Technical Bulletin

PJ 77/78 Gold Flash Plating of Solder Terminal No. 01 (1.3 mm)

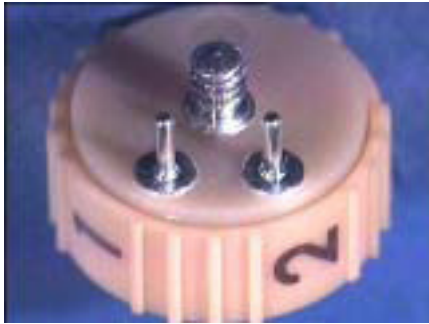
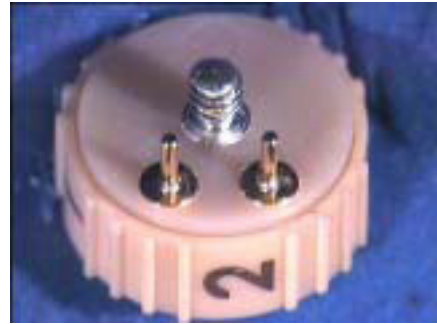
Sonion is pleased to announce that from March 2002, gold flash plating of solder terminal no. 01 will be gradually implemented on our PJ 77/78 Volume Controls.

The reason for this change is that the gold flash plating better reduces the tarnishing rate of the terminals than the current passivation process.

Compared to the previous version of solder terminal no. 01, the gold flash plating will have the following features:

- Reduces the tarnishing rate of the terminals better than the current passivation process
- Continuous good solder ability
